Subject: Oconee Nuclear Station
Docket Nos. 50-269, -270, -287
Response to Request for Additional Information
SQUG Resolution of USI A-46

RESPONSE TO RAI SQUG RESOLUTION OF
USI A-46

Attachment 1
Response to February 18, 1999
Request for Additional Information
On Unresolved Safety Issue A-46

Figure 1 Oconee Turbine Building Response Spectra

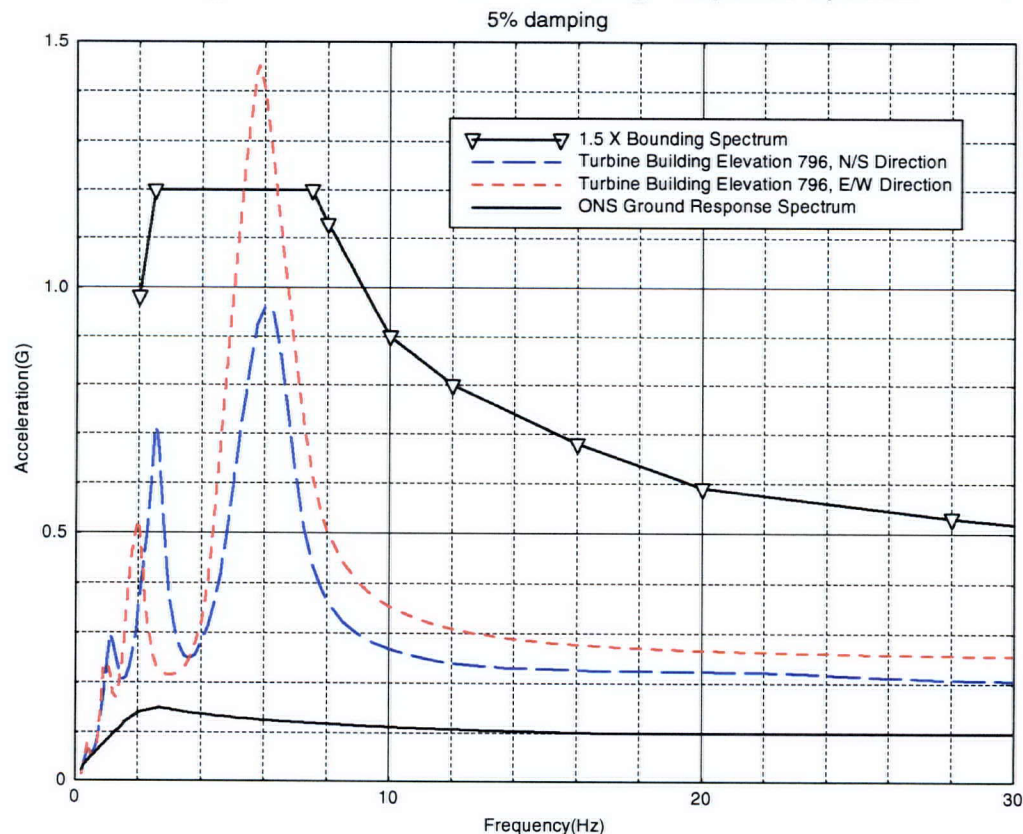
As described in the Oconee Seismic Evaluation Report, Method A.1 of GIP, Section 4.2, was used for comparing seismic capacity to seismic demand for equipment that is mounted below 40 feet above grade, and has a natural frequency greater than about 8Hz. However, there is a restriction for applying Method A.1 in accordance with GIP-2. The restriction is that the amplification factor established between the free-field response spectrum and the in-structure response spectra (IRS) will not exceed 1.5. For cases where this condition is not met, the use of Method A.1 may not be appropriate and may lead to non-conservative results. Provide a justification for the use of Method A.1 where this restriction was not met, or provide a description of the basis for finding the use of Method A to be acceptable.

Figure 1 shows the 5% damped ISRS for Elevation 796 compared to 1.5 times the Bounding Spectrum and the 5% damped Oconee licensing basis rock response spectrum. While the maximum amplification is about 11 in the East/West direction at the primary structural frequency of about 5.8 Hz., the amplification is 4.3 for frequencies above 8 Hz. Note that these amplification factors are computed relative to the Oconee licensing basis rock spectrum. As discussed in Enclosure 2, the ISRS were computed using an El Centro time history input. Amplification factors relative to that time history are 6.9 at the structural frequency and 3.1 above 8 Hz.

- The Turbine Building at Oconee where Method A was used is a typical nuclear plant heavily braced steel frame building for which the 1.5 amplification factor is applicable as described in the SSRAP Report and Page 4-16 of GIP-2.
- The Oconee licensing basis conservative ISRS used for A-46 show amplifications of more than 1.5 due to conservatism in the analytical methodology, as discussed in Attachment 1 to this response. More realistic, median centered response spectra computations would result in ISRS which would not greatly exceed 1.5 times the licensing basis free field spectrum above 8 Hz. In addition, the median centered ISRS would fall well below 1.5 times the Bounding Spectrum.

Figure 8b.1.3.1

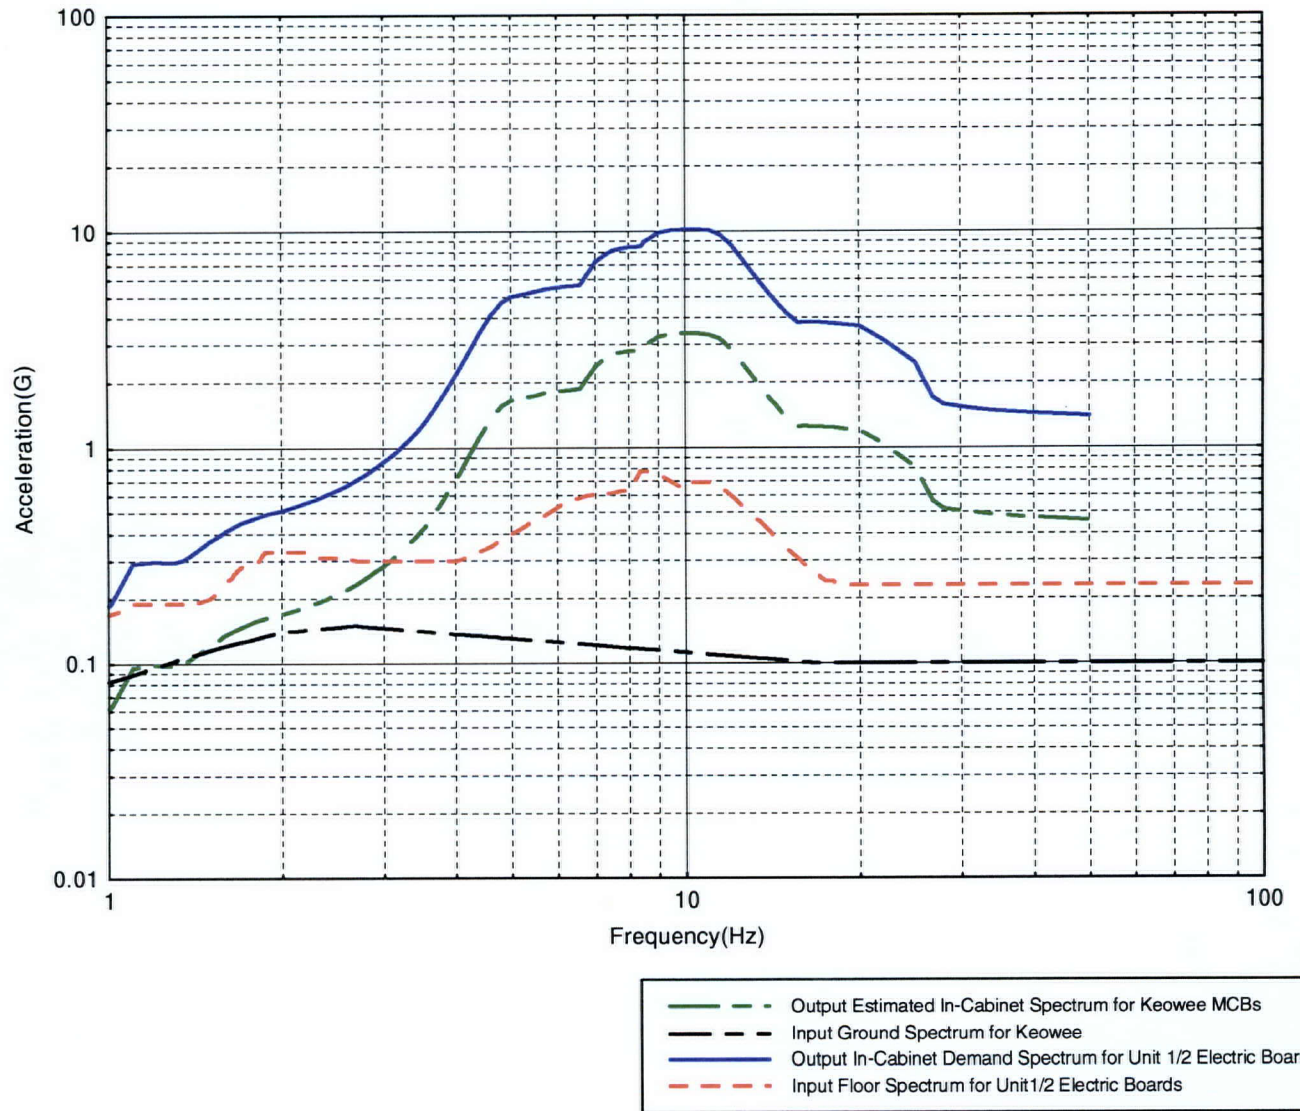
Provide two examples from each of the evaluation approaches performed to screen relays by the EPRI Relay Generic Equipment Ruggedness Spectra (GERS), the Generic Implementation Procedure (GIP) Switchgear Relay Method, seismic test reports, and seismic analyses.

The easiest method of estimating the in-cabinet spectrum for the Keowee boards was to use the envelope generated for the Unit 1/2 boards. However, this method was too conservative because the input spectrum for the Unit 1/2 boards had much higher spectral accelerations than the input spectrum for the Keowee boards. The input and output in-cabinet spectra for the Unit 1/2 boards are given in Figure 8b.1.3.1. Also shown in Figure 8b.1.3.1 are the input ground response spectrum and the estimated in-cabinet spectrum for the Keowee boards.

A more accurate method of estimating the in-cabinet spectrum for the Keowee boards was to determine the worst-case acceleration amplification for the Unit 1/2 boards based on the control board natural frequencies and the input and output in-cabinet spectra given in Figure 8b.1.3.1. The cabinet natural frequencies are easily seen in the figure because they produce acceleration amplifications above the input spectral accelerations. The in-cabinet spectrum for the Unit 1/2 boards shows acceleration amplifications in the frequency range from 5 to 20 Hz. The in-cabinet spectrum for Keowee could be estimated by multiplying the ground response spectrum by the computed worst-case amplification factor. This method produces an accurate estimate of the peak acceleration, but it severely over-estimates the spectral accelerations in the lower frequency range and produces an in-cabinet spectrum with an inappropriate spectral shape.

To correct the spectral accelerations in the lower frequency range, the final estimated in-cabinet spectrum for Keowee was computed by shifting the Unit 1/2 board spectrum back up until the spectral accelerations in the lower frequency range were approximately the same as the input ground spectrum for Keowee. This final method conservatively over-estimates the peak acceleration of the in-cabinet spectrum with a corresponding cabinet amplification several times greater than the maximum amplification factor given in the GIP.

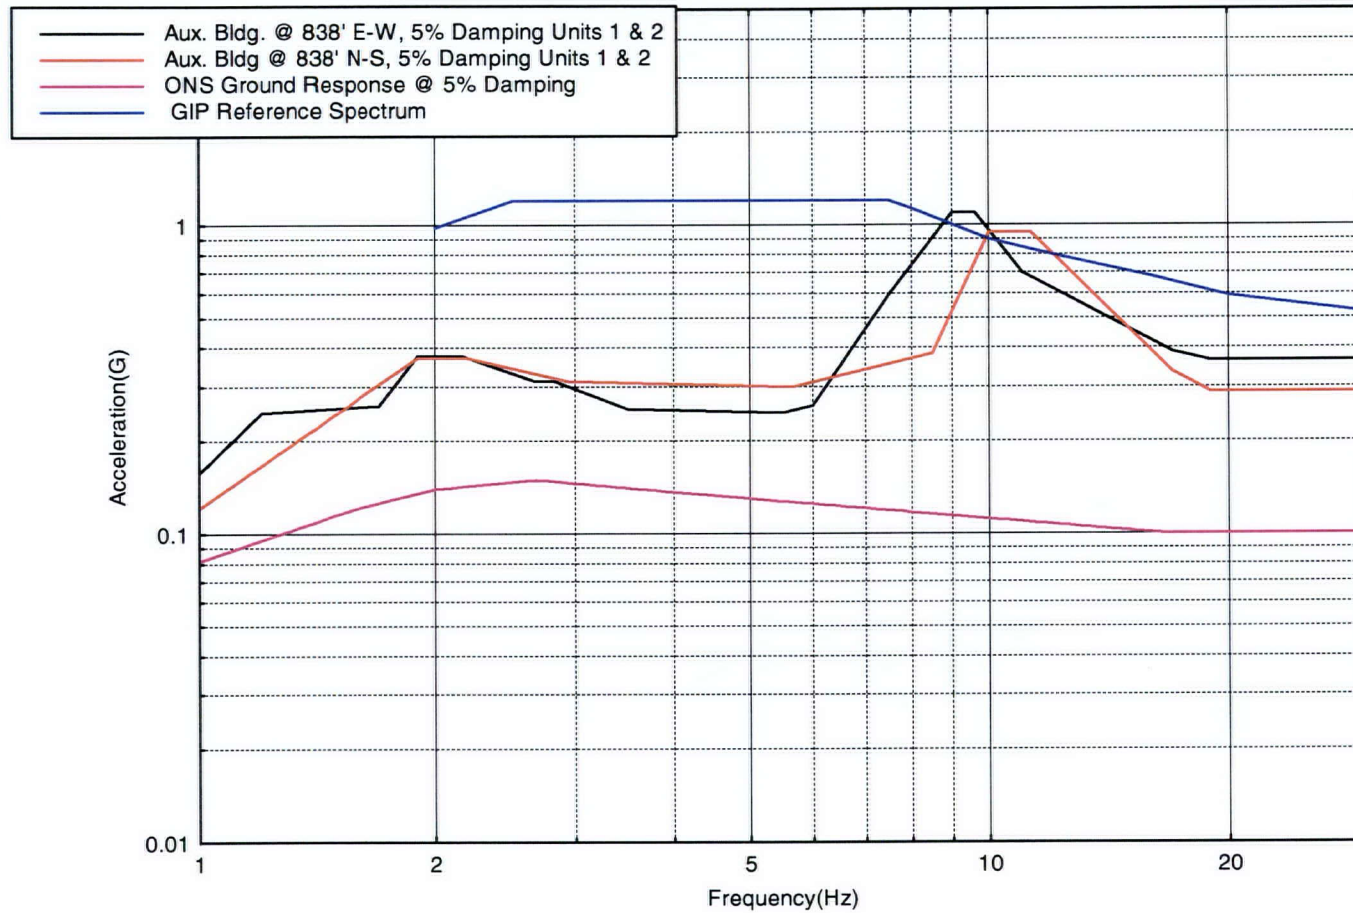
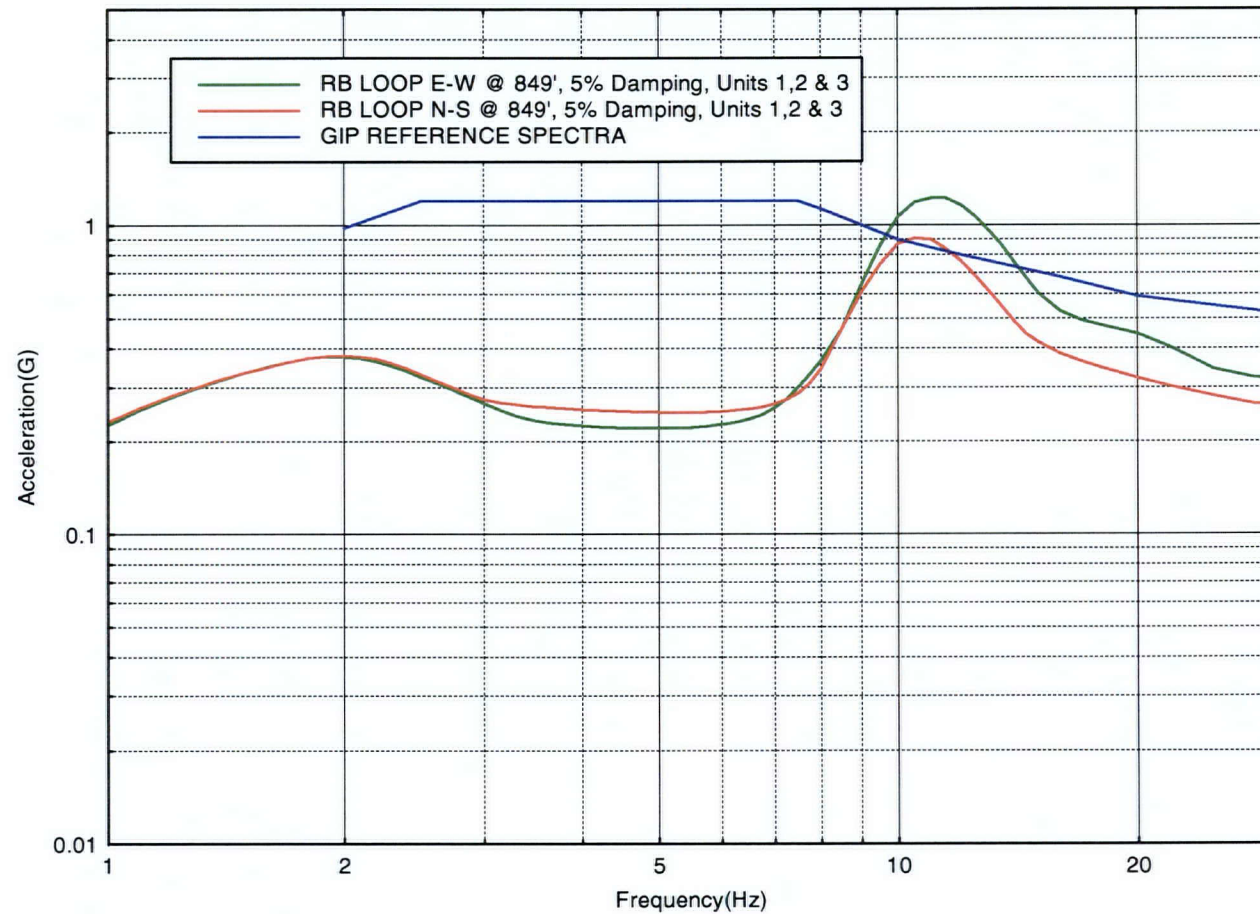
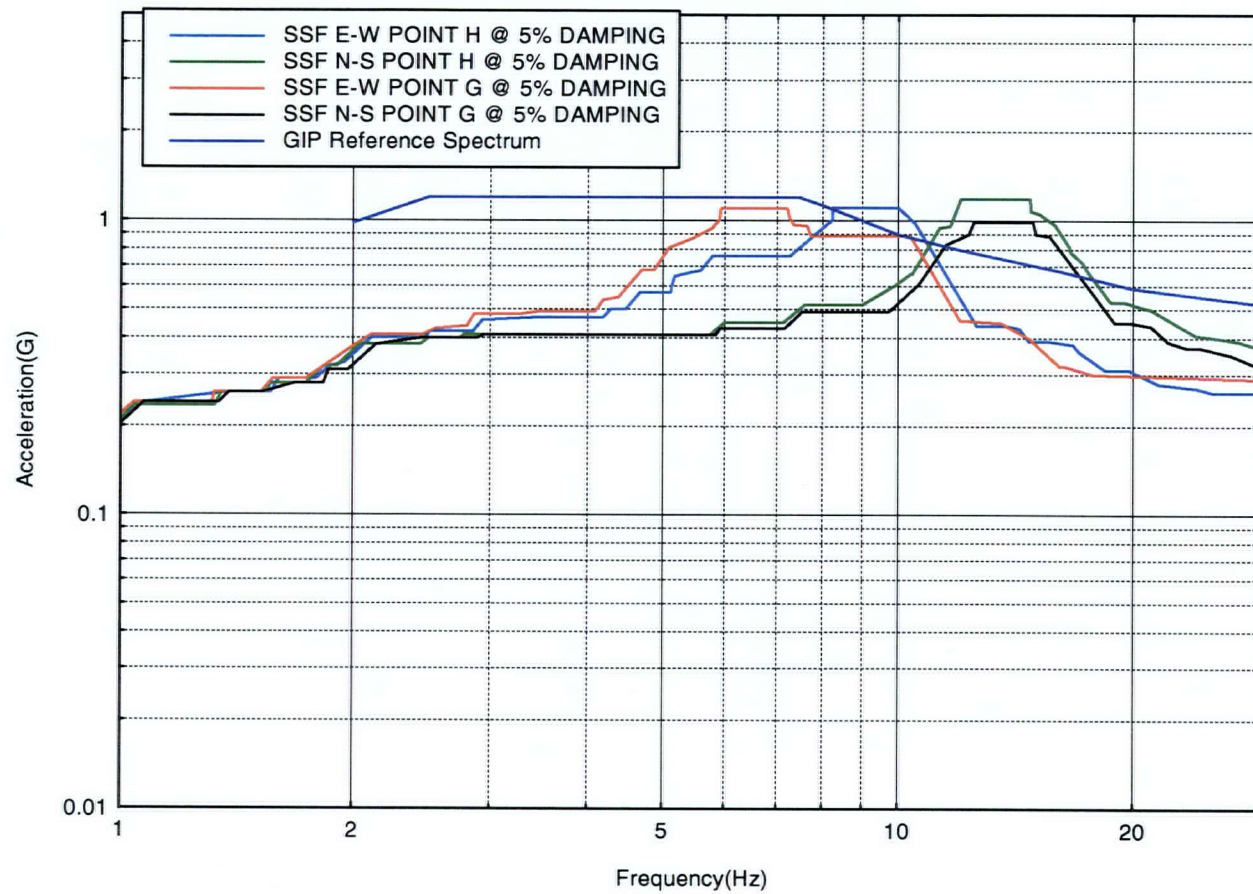
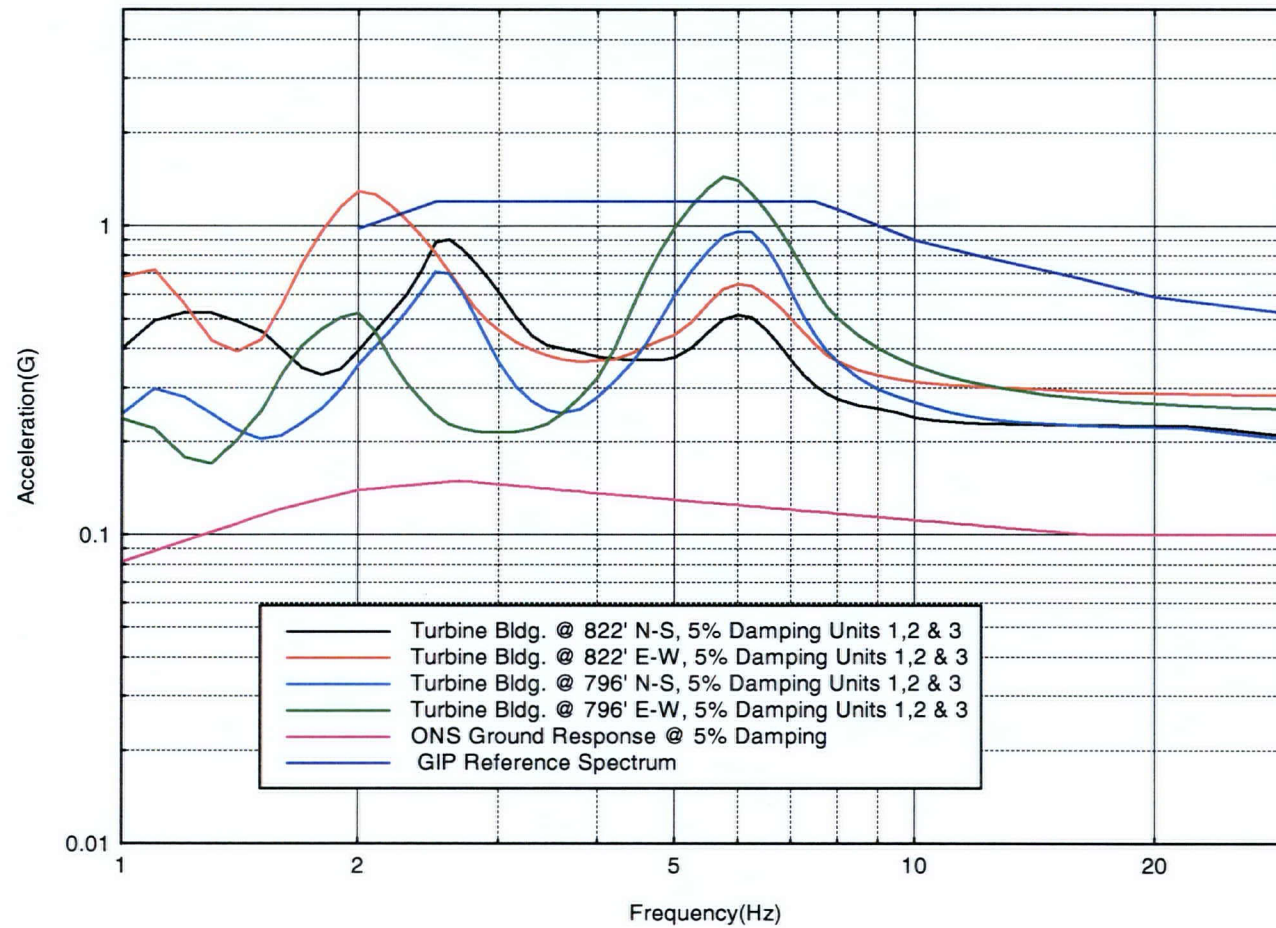
Provide graphical comparisons of IRS vs. 1.5 x Bounding Spectrum for each of the floor elevations identified in Table 5-3.
